**CERTIFICATE OF APPROPRIATENESS**

**Property:** 1034 East 14<sup>th</sup> Street, Lot 9, Block 119, North Norhill Subdivision. The property includes a historic 1,152 square foot, one-story wood frame single-family residence and a detached garage situated on a 5,200 square foot (50' x 104') interior lot.

**Proposal:** Alteration – Porch Columns and Windows

**PORCH COLUMNS**

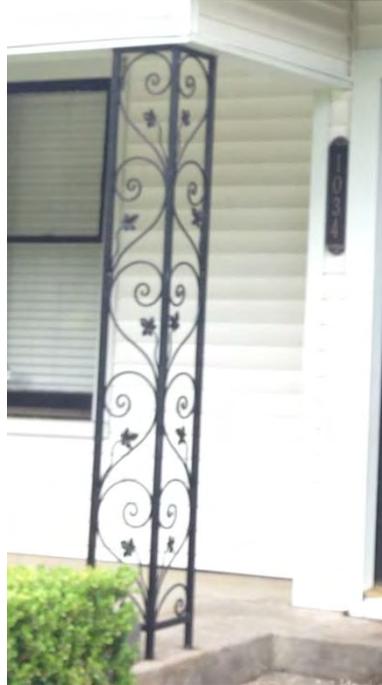
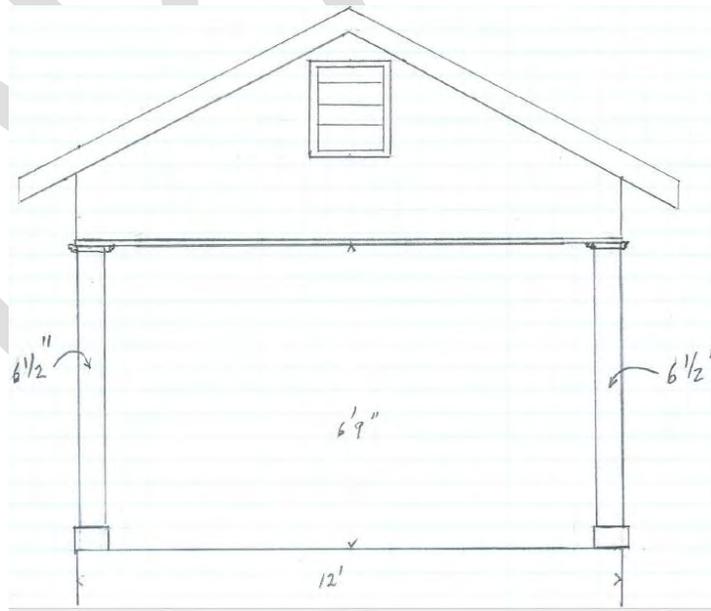
Two non-original porch columns proposed to be replaced

**Exterior Materials:** Replace the two existing non-original wrought iron porch columns with two square wood porch columns. The new columns with measure 6" thick and 6' 9" tall.

**Recommendation:** **Partial Approval: Approve replacing the porch columns. Deny replacing the windows.**
